**ADDENDUM NO. 3**

**PROJECT: 5524**  
**February 5, 2024**

**BAKERSFIELD CITY SCHOOL DISTRICT  
MUNSEY ELEMENTARY SCHOOL  
HVAC REPLACEMENT  
3801 BRAVE AVENUE  
BAKERSFIELD, CA 93309**

**DSA APP# 03-122489**

Sheet No.:  
**A2.10**  
Release: ADDENDUM 3

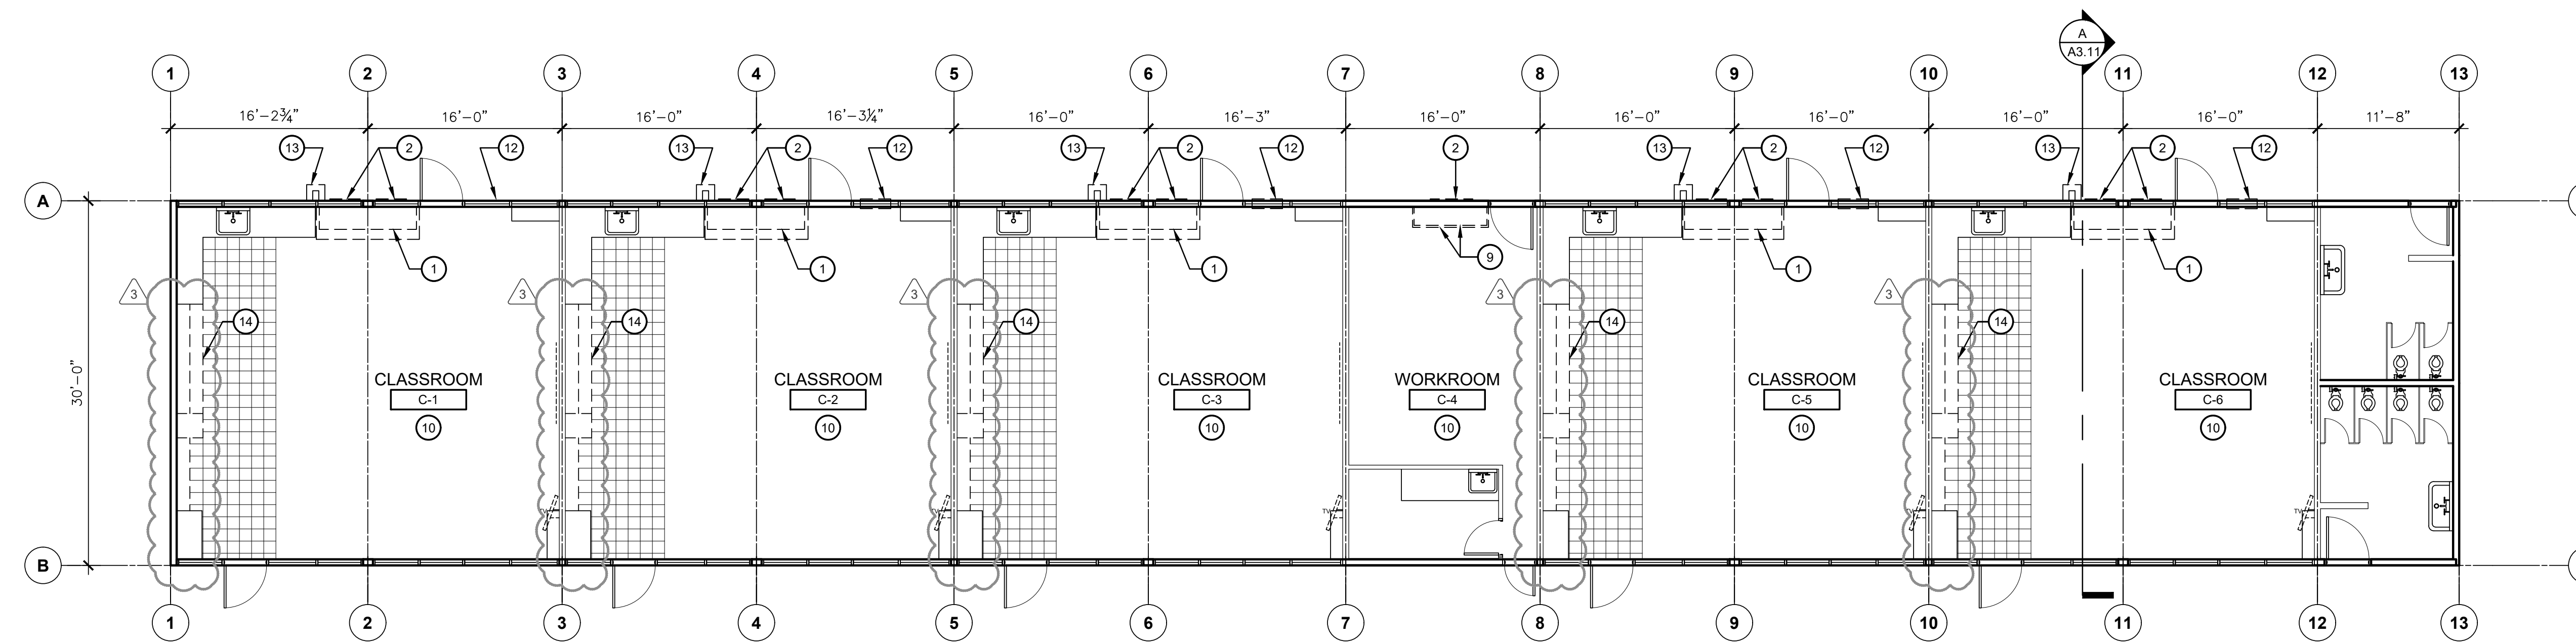
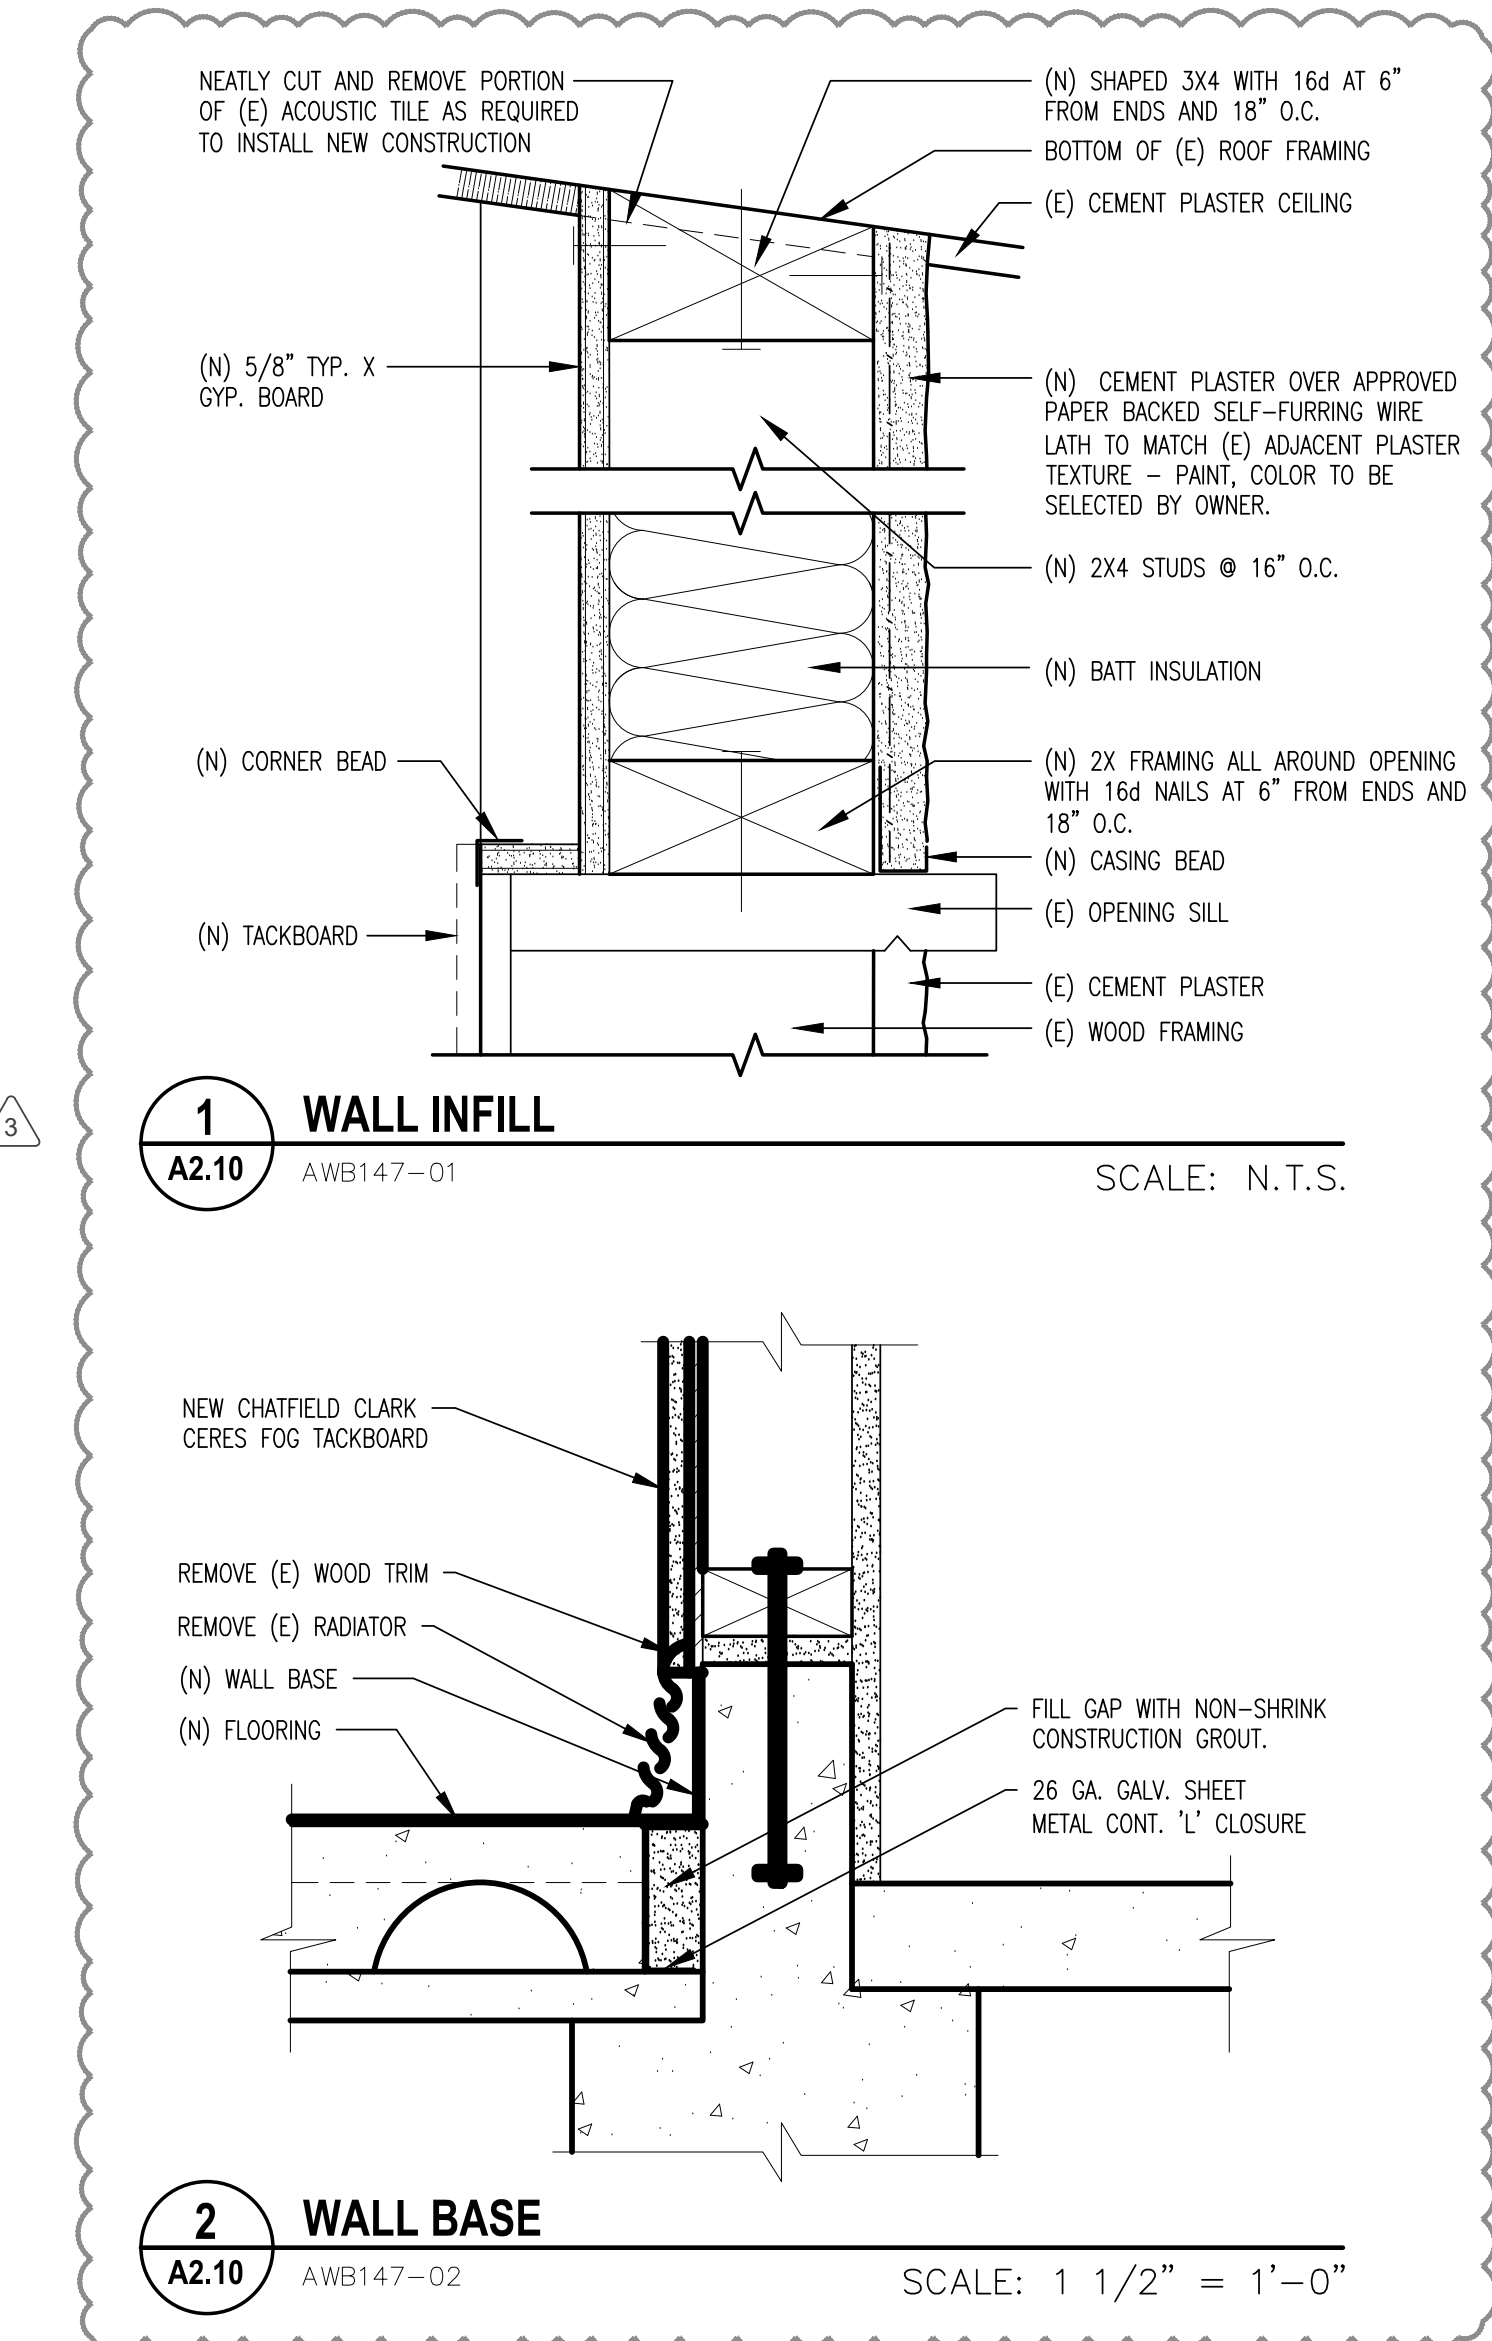
- 3.06 Remove existing barometric relief vent and metal panel infill and infill opening as per detail 2/A2.10, also see revised sheets M2.31, M2.41, and M2.51.

- 3.07 Sheets A2.10, A2.11, A2.20, and A2.21 have been revised to indicate the removal of a portion of existing cabinets at each of the classrooms.
- 3.08 Remove existing hydronic piping on covered walkway roof between building A and C. The district will assess the condition of the roof after piping is removed to determine if foam roof re-coating will be needed.
